**Planning Commission
Council Chambers
July 19, 2022 – 6:00 p.m.
233 South Main Street, Monroe, Ohio**

TO: Members of the Monroe Planning Commission
FROM: Kameryn Jones
Assistant Development Director

DATE: July 19, 2022
RE: Information Packet for July 19, 2022 Planning Commission Meeting at 6:00 p.m.

III. Case No. 2022-7-8. Consideration of Site Plan Application for a Medical Marijuana Dispensary on Clarence F Warner Drive

PHOTOMETRIC PLAN	
DATE: 06/21/2022	DRAWN BY: CCC
NOT FOR CONSTRUCTION

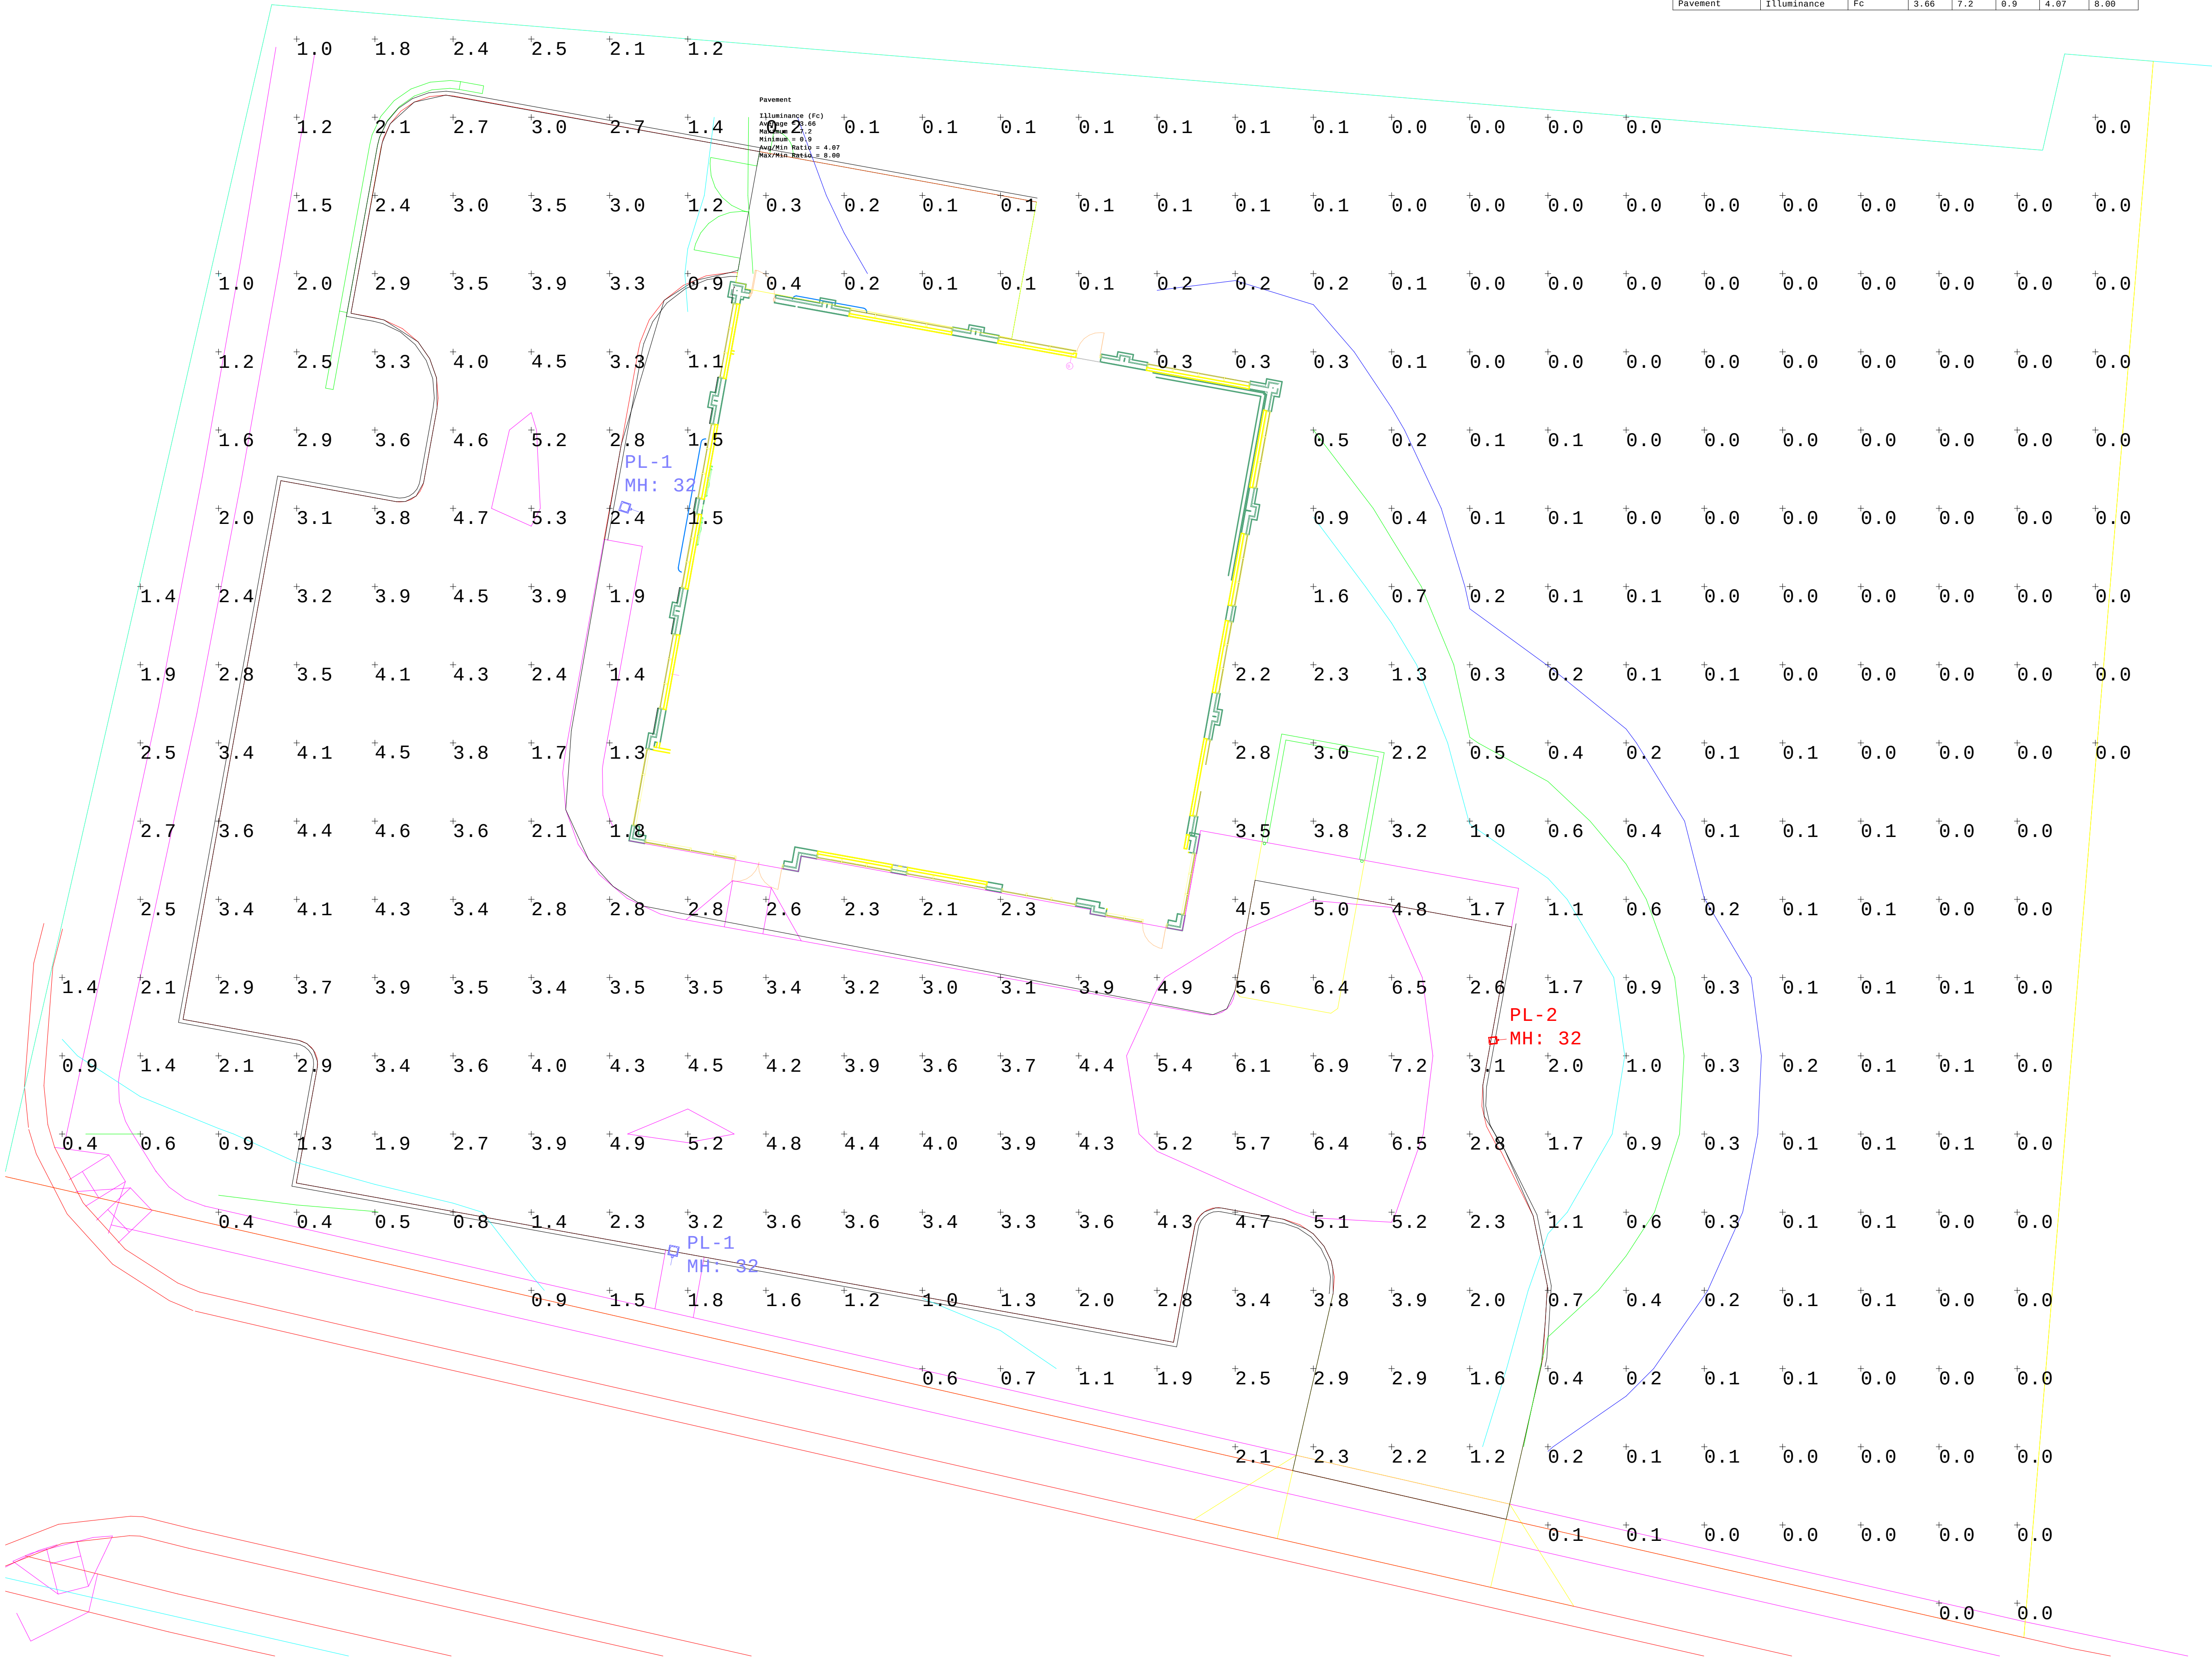
- The lighting plan submitted appears to show the site is under-lit in two small areas along the access drive and parking areas where the minimum required is 0.3 fc. Please revise.
